Interactive comment on “Evaluation of TRMM rainfall estimates over a large Indian river basin (Mahanadi)” by D. Kneis et al.

D. Kneis et al.

Received and published: 7 April 2014

Fig. 1. Modified Fig. 2

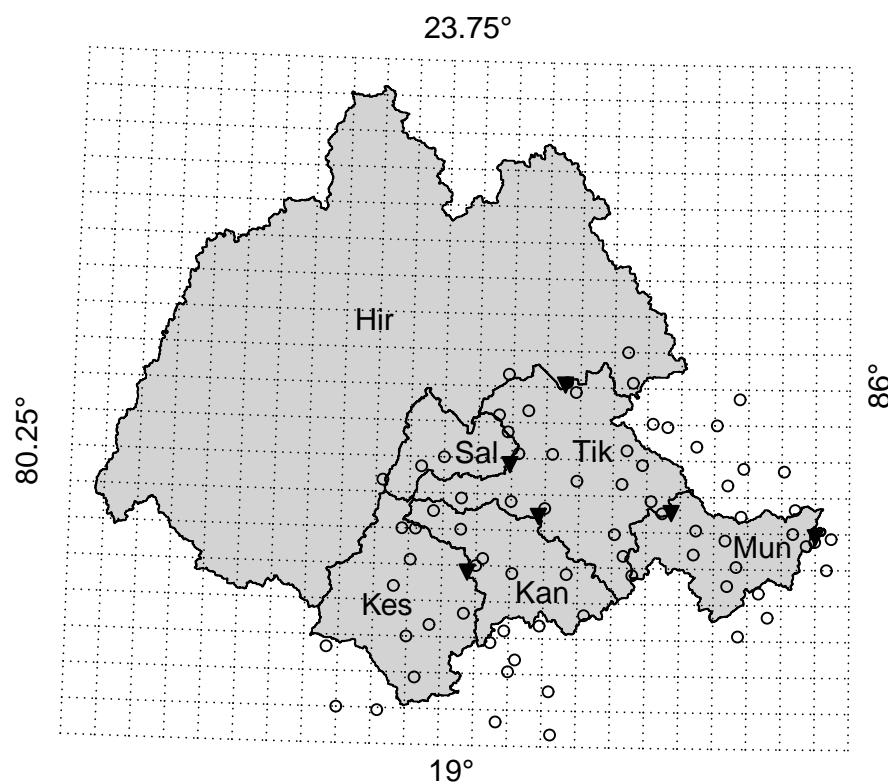
5) The situation of gauges in Figure 1 and Figure 2 is not the same. Please show the topography of study area in figure 1 too.

Please note that Fig. 1 shows stream gauges whereas Fig. 2 shows rain gauges. For clarification, we suggest to add the stream gauges (triangle symbols) and the sub-basin identifiers in Fig. 2. The altered figure was attached.

Using the topography as a background makes the figures hard to read. We suggest to keep the background as is. Since WGS84 coordinates are provided in the figures, interested readers can easily view/download any geo data of interest using web resources
